Network Video Recorder
Version: V3.4.96 build170921
Release Note
(2017-10-16)

Reason of Upgrade
Add and optimize functions for better performances on E/K/I series NVR.

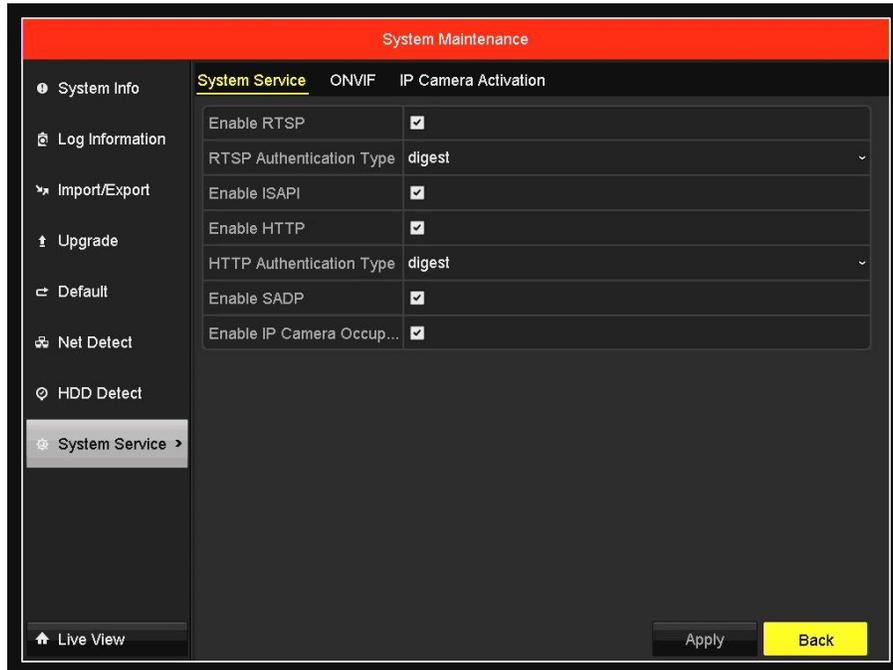
Firmware Upgrade
New Features
1. **[System Service]**
    (1) Delete PSIA server/client protocol;
    (2) User can disable/enable RTSP protocol (only valid for server mode when client receives stream from NVR) and choose RTSP authentication type between digest and digest &basic;
    (3) User can disable/enable ISAPI protocol;
    (4) User can disable/enable HTTP protocol and choose HTTP authentication type between digest and digest &basic;

(5) User can disable/enable SADP protocol;

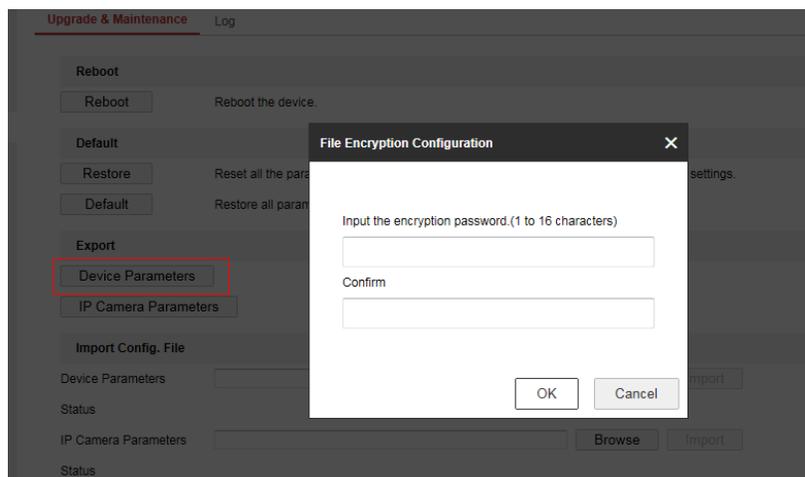
(6) User can disable/enable IP camera occupation detection, when this function is enabled, NVR will detect whether IP camera is already connected to other device/client.

(7) NVR's device parameters will be encrypted by user's custom encrypt key, encrypt key is required when user imports it;

2. **[ONVIF]**

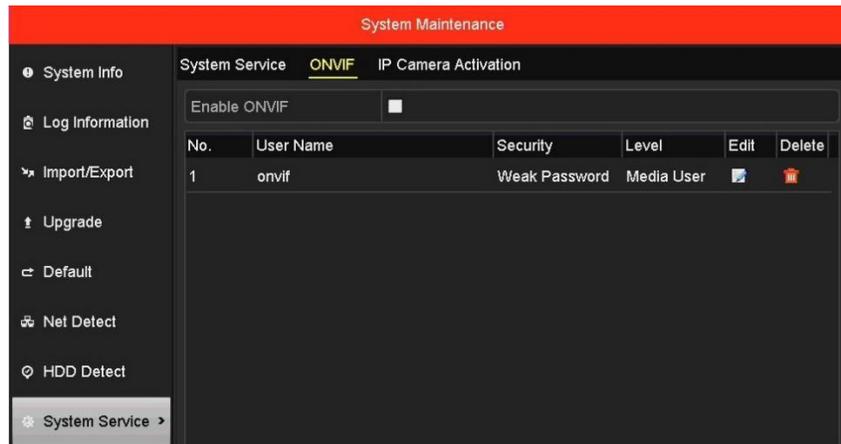
User can disable/enable ONVIF protocol, create independent account for ONVIF server service.

3. **[IP Camera Activation]**

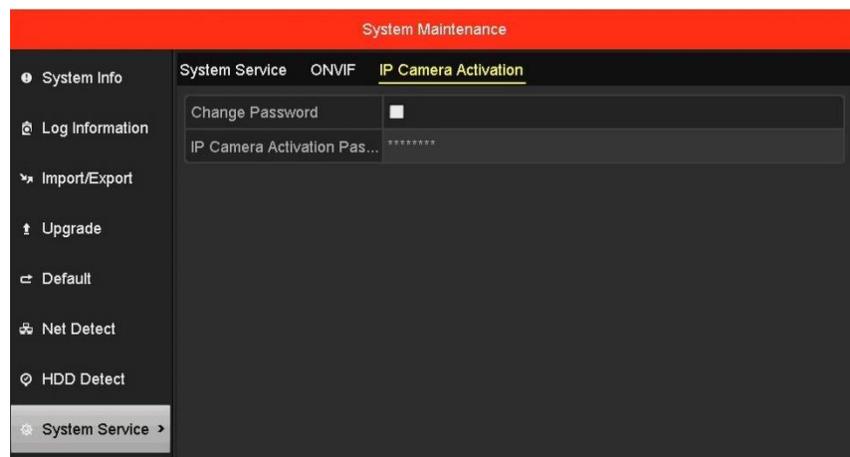
In previous version, NVR uses admin password to activate IP camera. From this new version, users can set IP camera activation password independently which is not required to be same with admin password.

4. [**3D PTZ**]

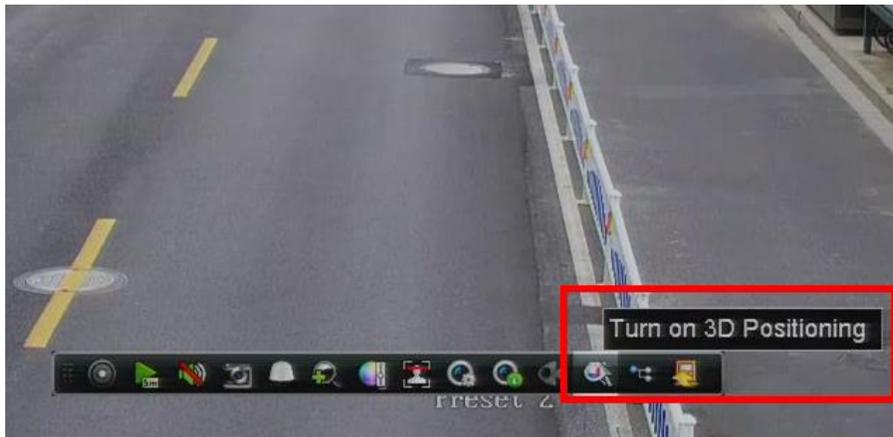
K/E series NVR support control 3D PTZ function in live view menu (only I series NVR supports this function in previous version).
